ARCHITECTURAL REVIEW BOARD MEETING
CITY HALL, 385 SOUTH GOLIAD STREET, ROCKWALL, TEXAS
JULY 29, 2025 IN THE CITY COUNCIL CONFERENCE ROOM AT 5:00 PM

PROJECT COMMENTS

PROJECT NUMBER: SP2025-032
PROJECT NAME: Site Plan for 855 Whitmore Drive
SITE ADDRESS/LOCATIONS: 855 WHITMORE DR

LANDSCAPE PLAN

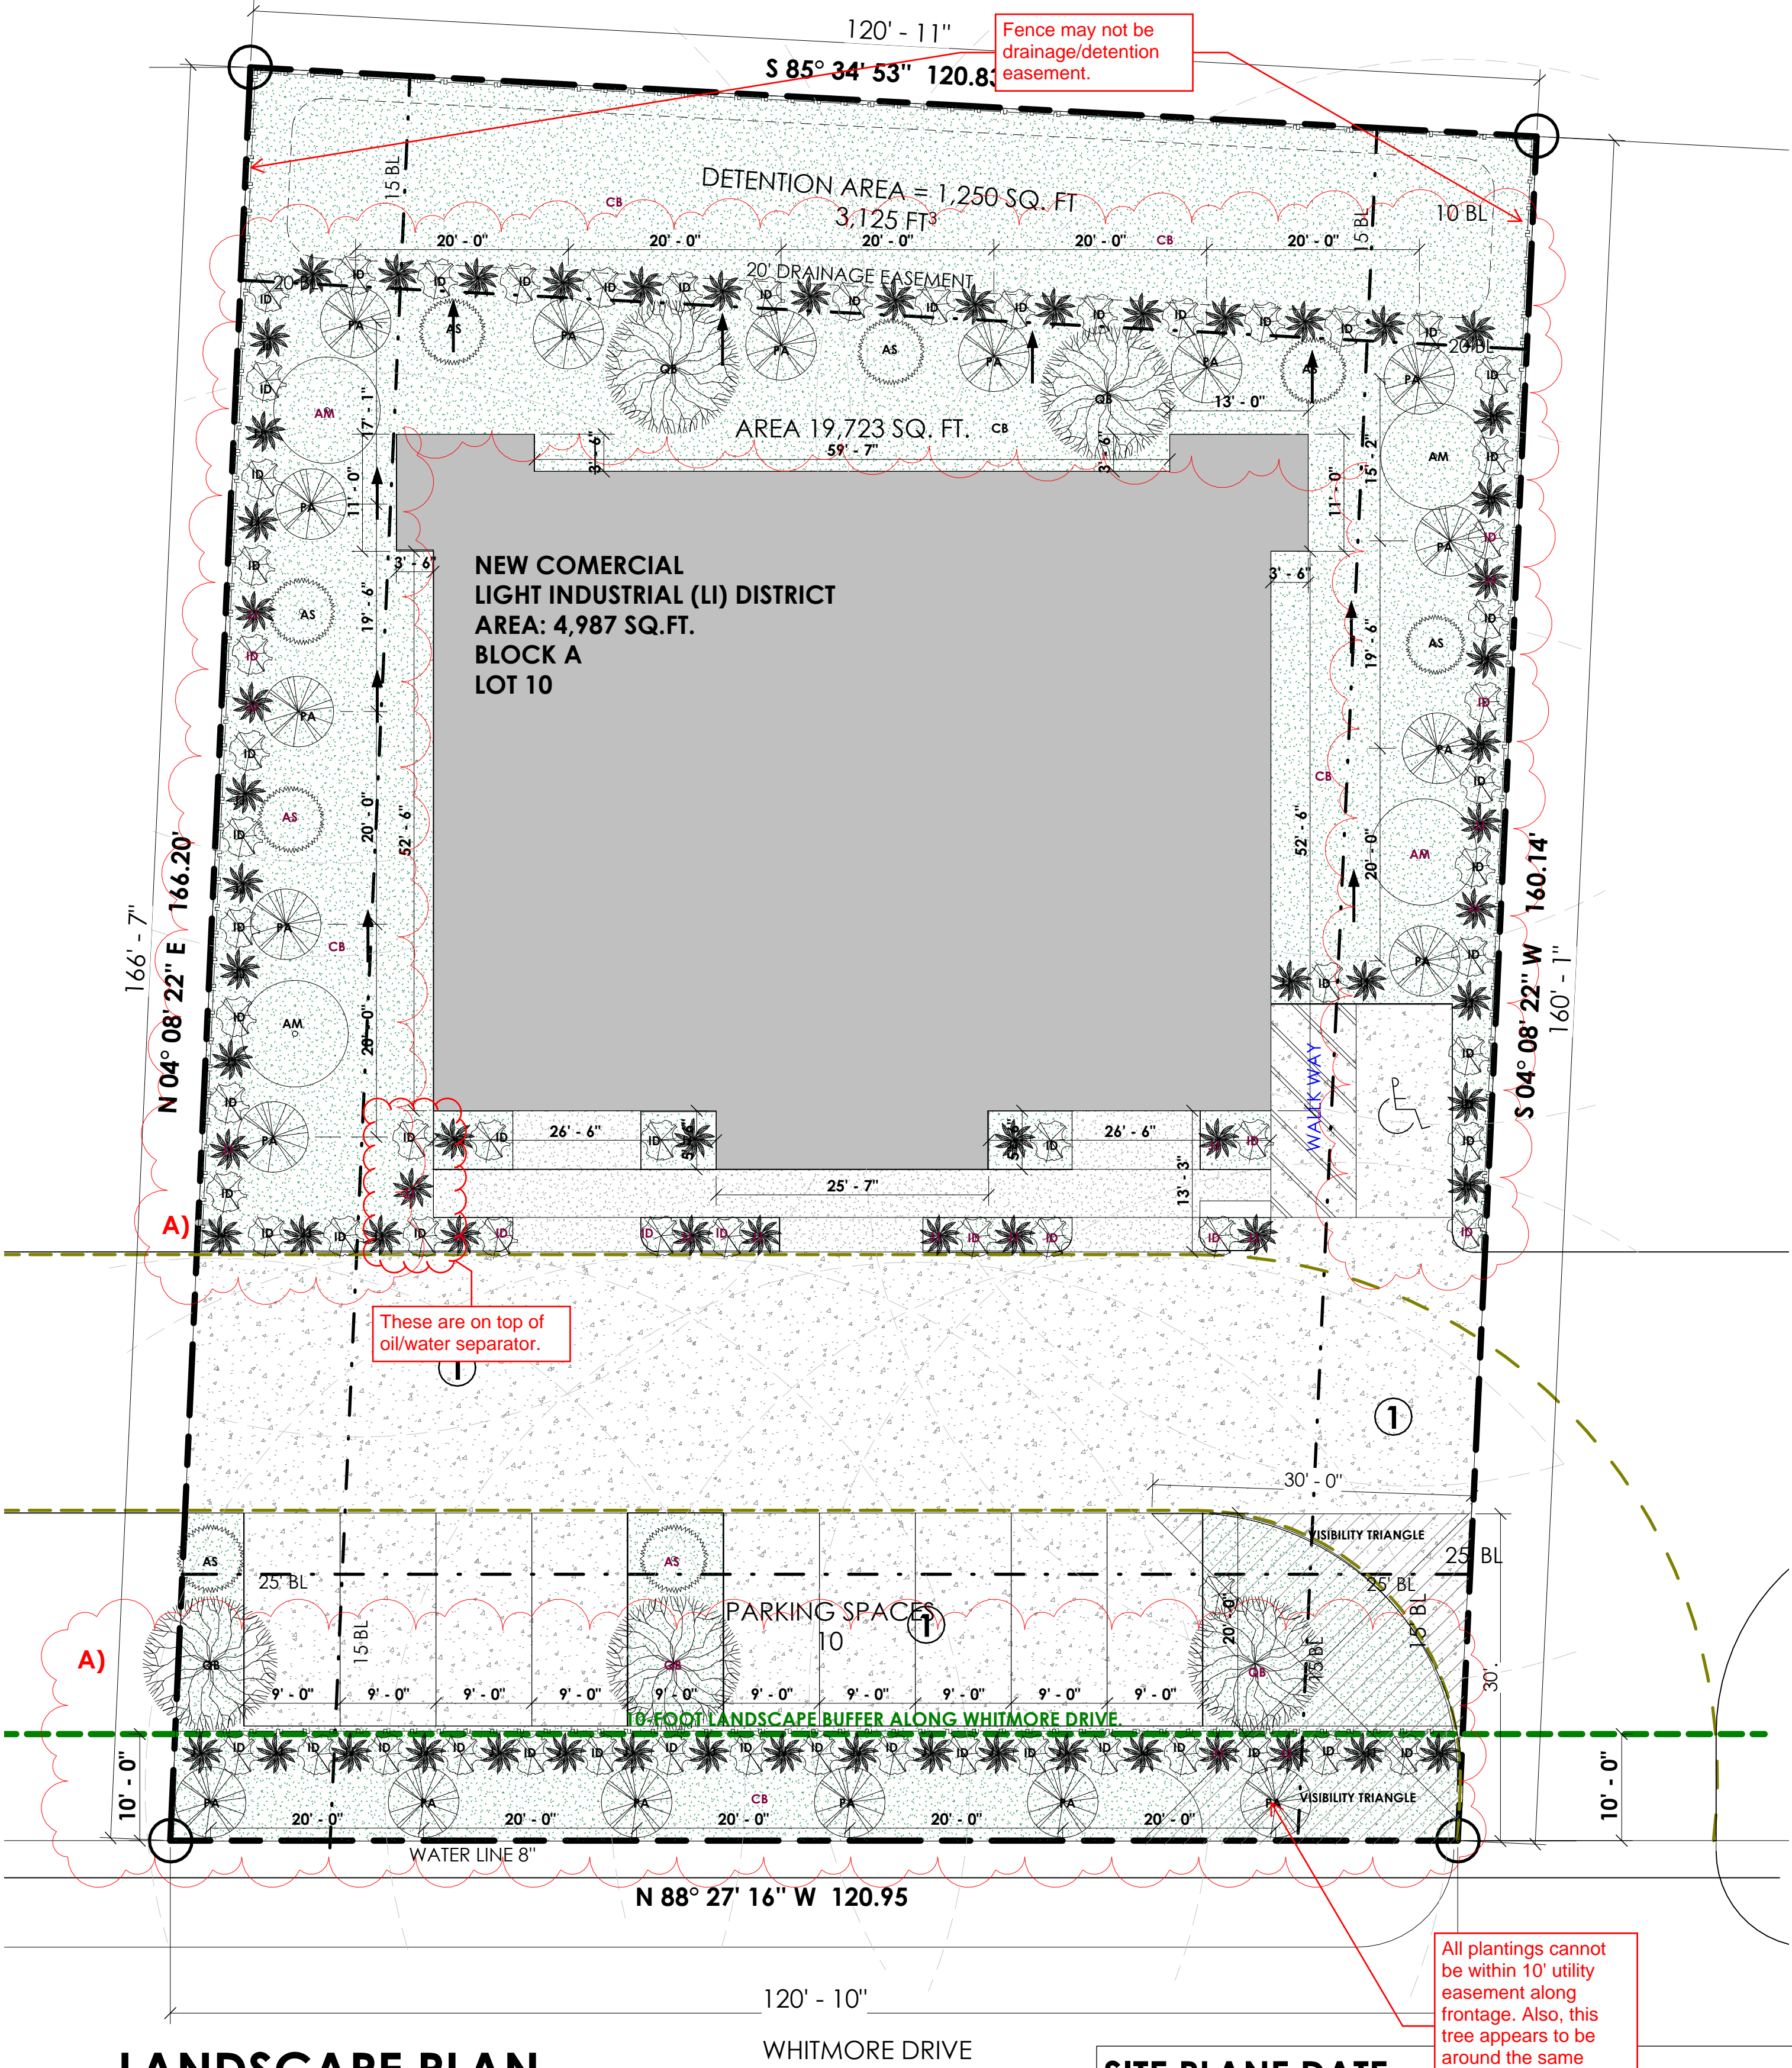
M.7 Landscape Plan.

- (1) All landscape buffers are required to incorporate a 30" berm and shrub row. In this case, there does not appear to be a berm in the landscape buffer. Please delineate and label the berm. In addition, the berm and landscaping cannot be within any utility easements. Given this, the landscape buffer will need to be shifted back. (Subsection 05.01, of Article 08, UDC)

07/23/2025: 1. Caddo Maples are extremely hard to locate (FYI)

2. Make sure and wrap trunks of Maples to prevent sunscald for 1st year

3. Better varieties of Bermuda turfgrass that are more shade, drought, cold and wear tolerant than Common Bermuda such as Tahoma 31, TifTuf

LANDSCAPE PLAN

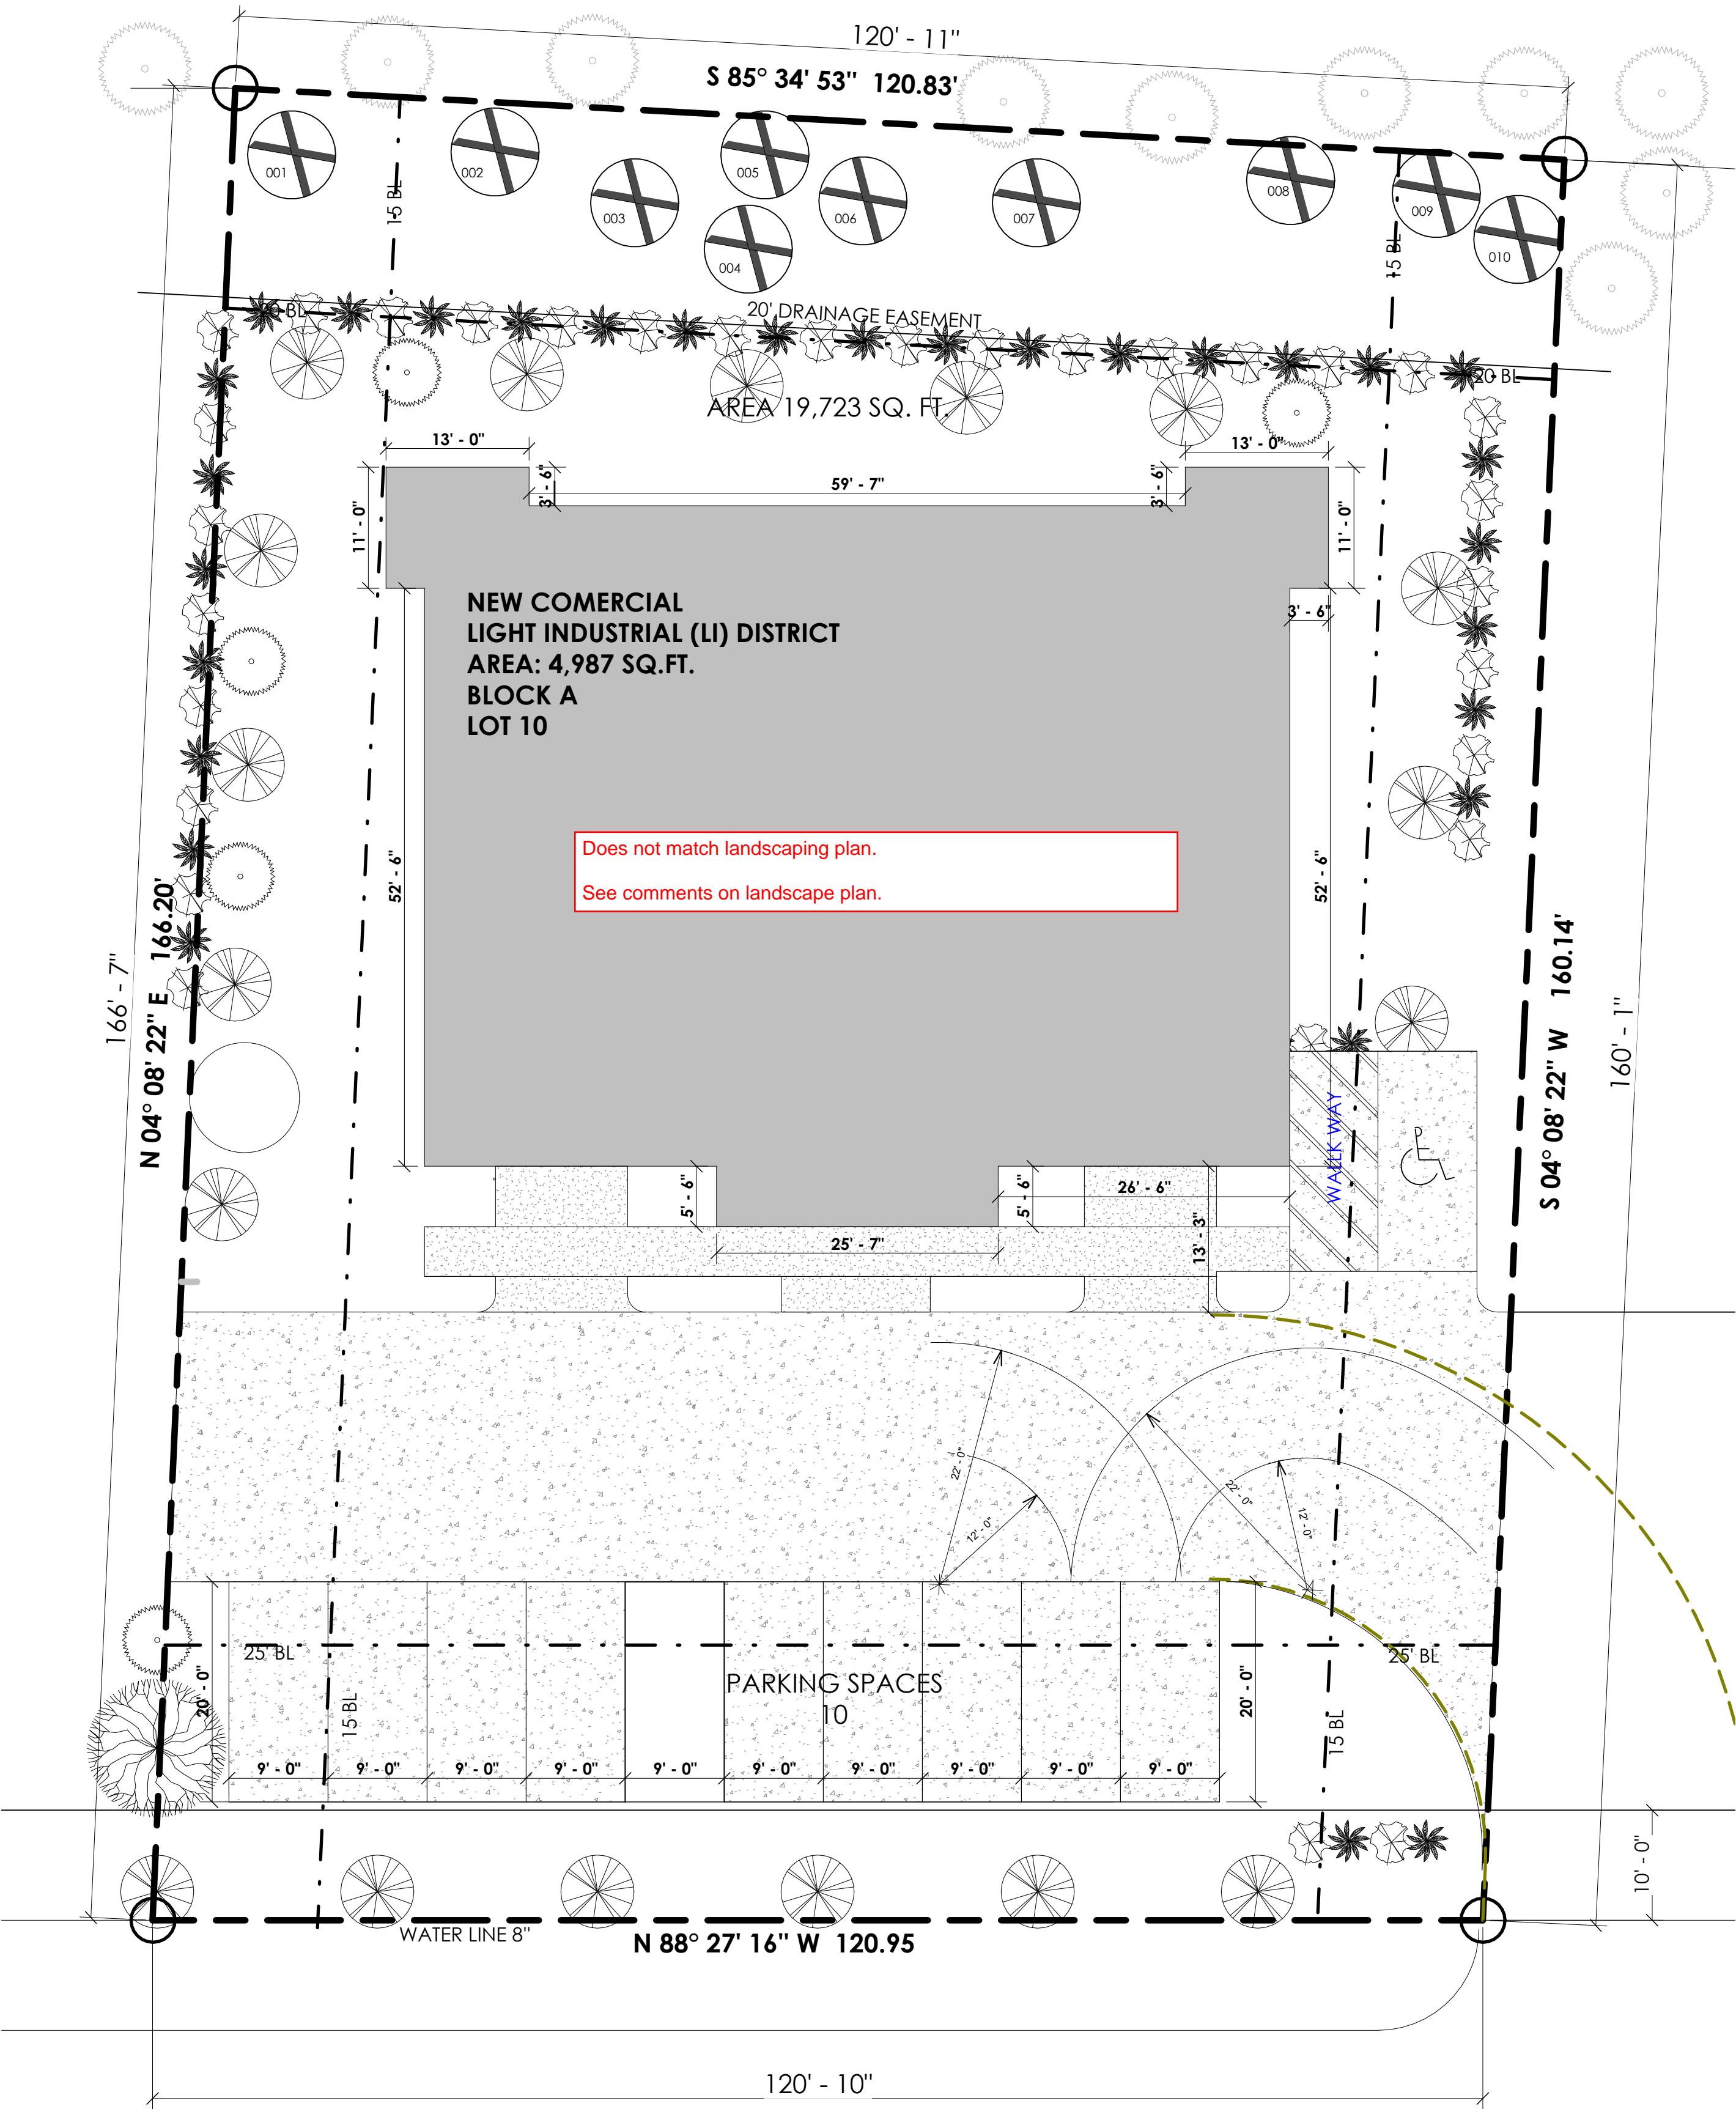
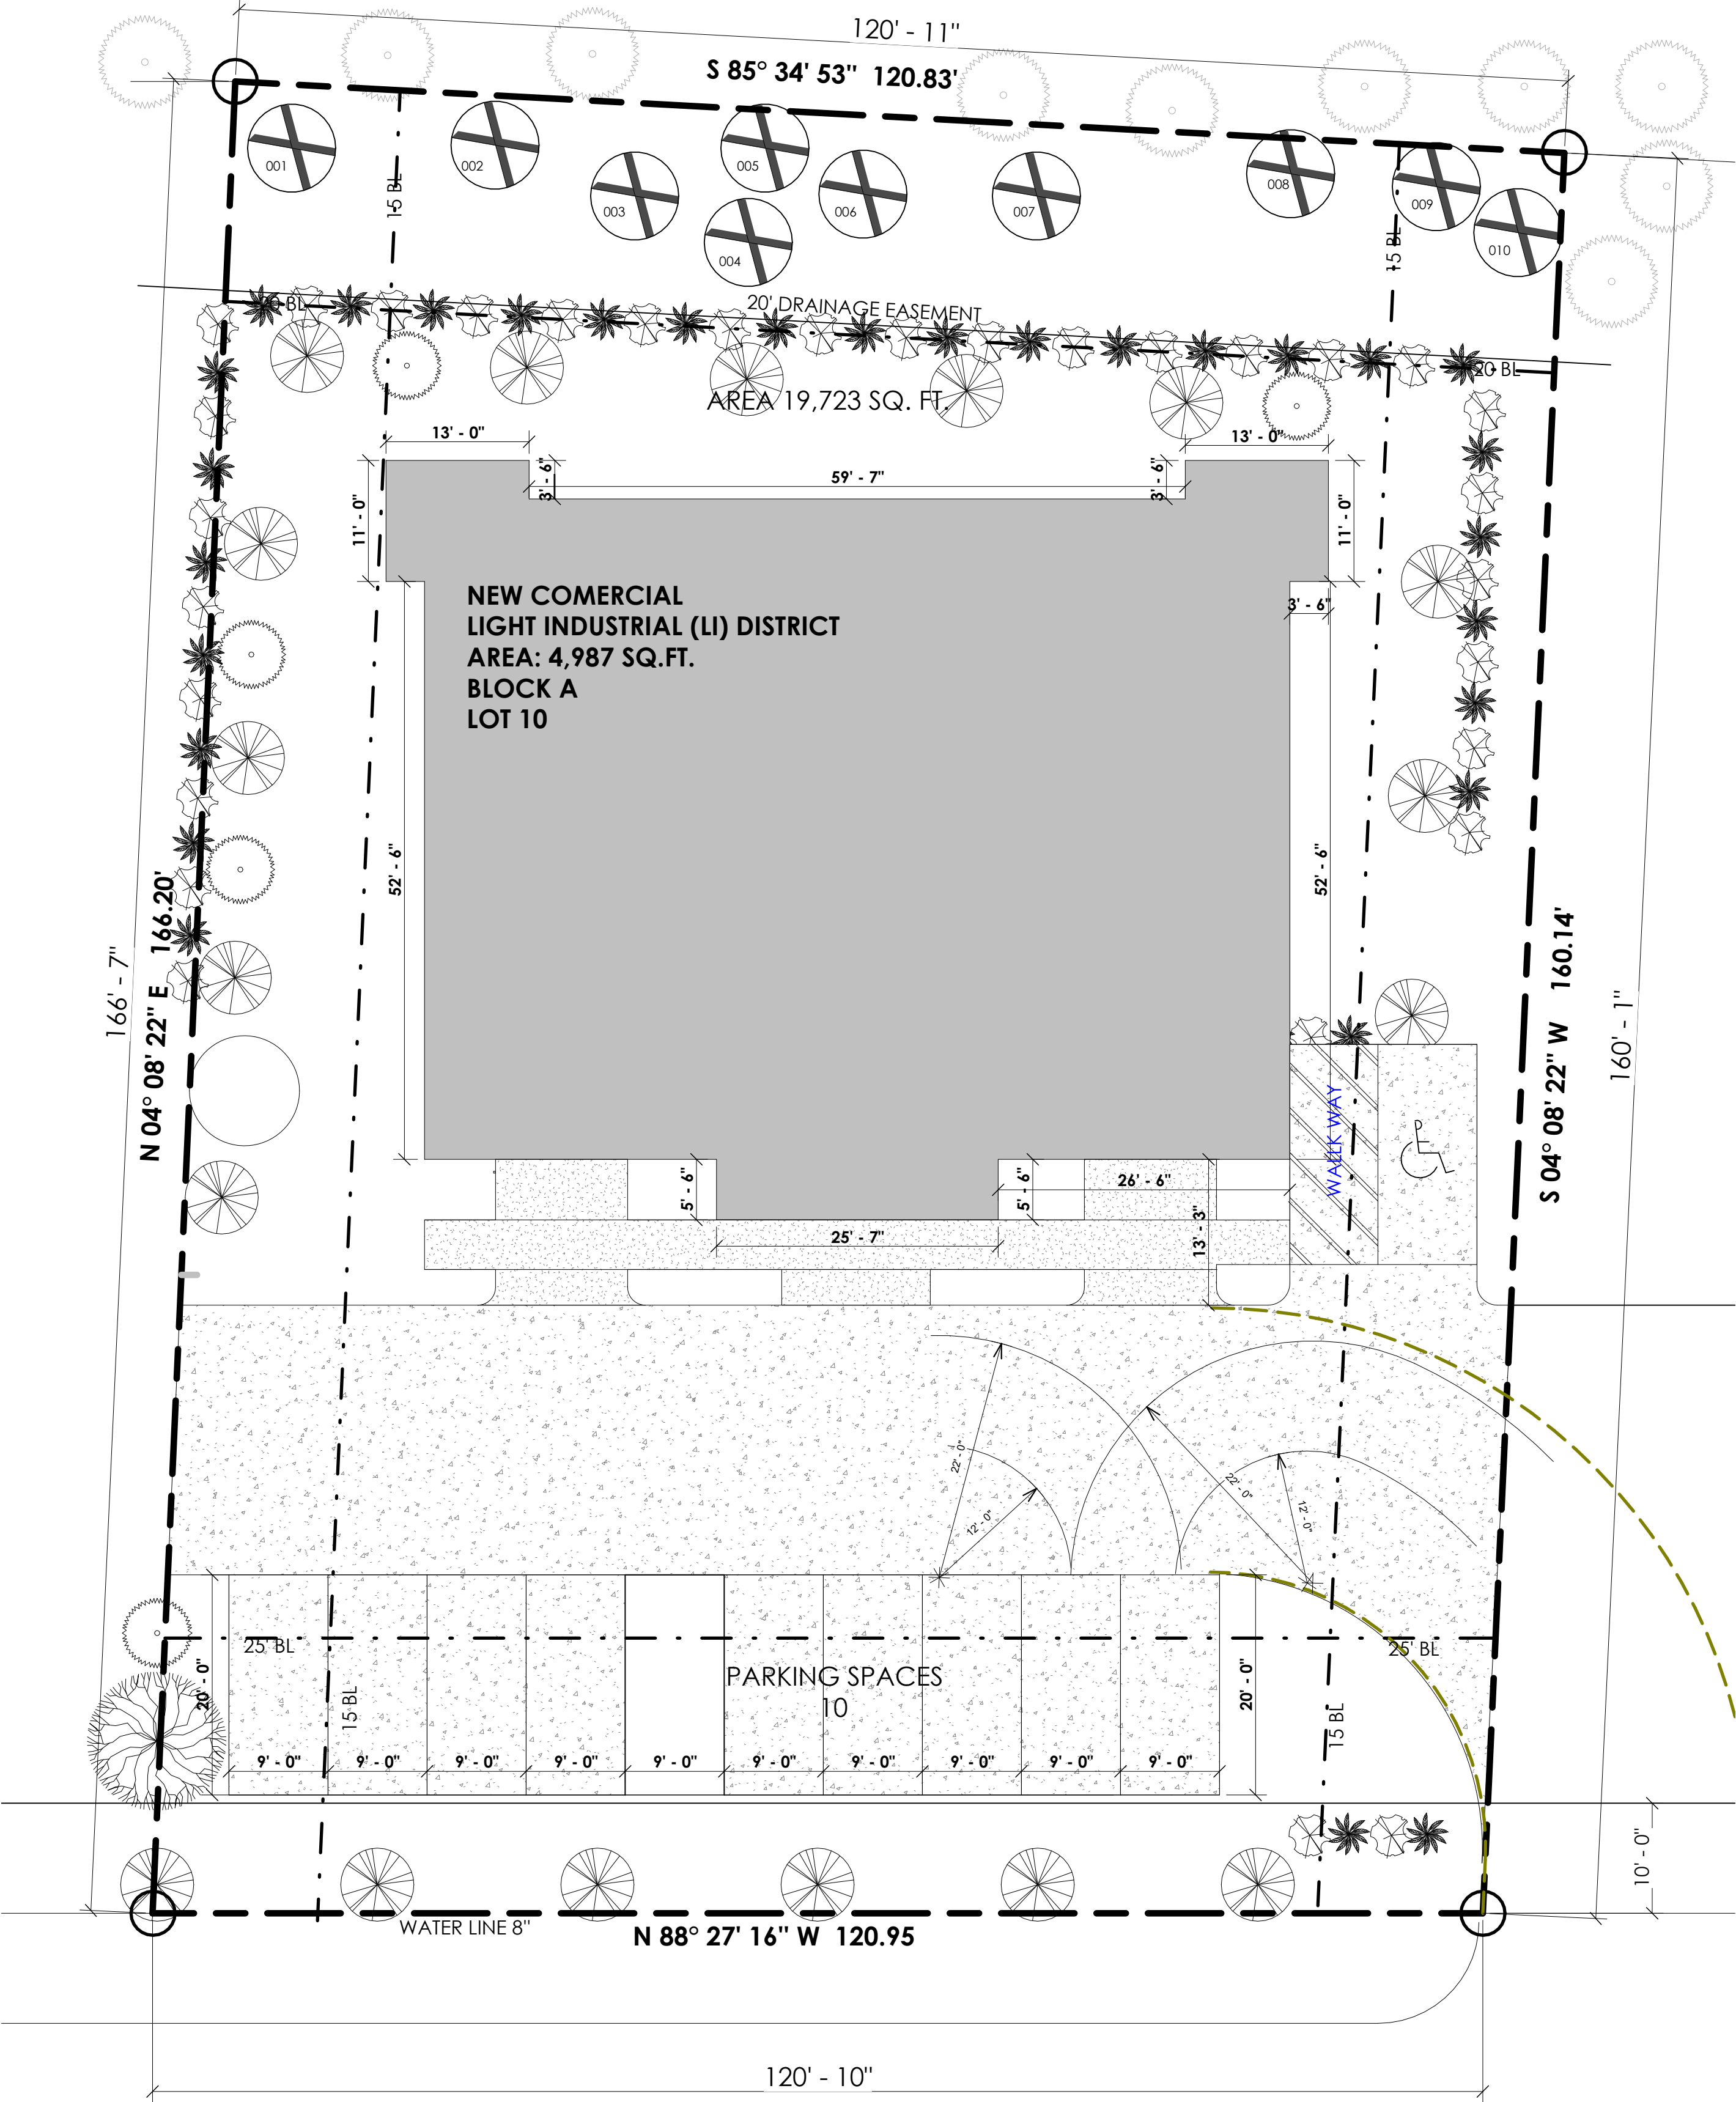
M.8 Treescape Plan

- (1) The applicant is removing 40 caliper inches and planting 148 caliper inches. Given this, the mitigation is satisfied. (Section 05, of Article 09, UDC)

07/23/2025: Tree mitigation approved
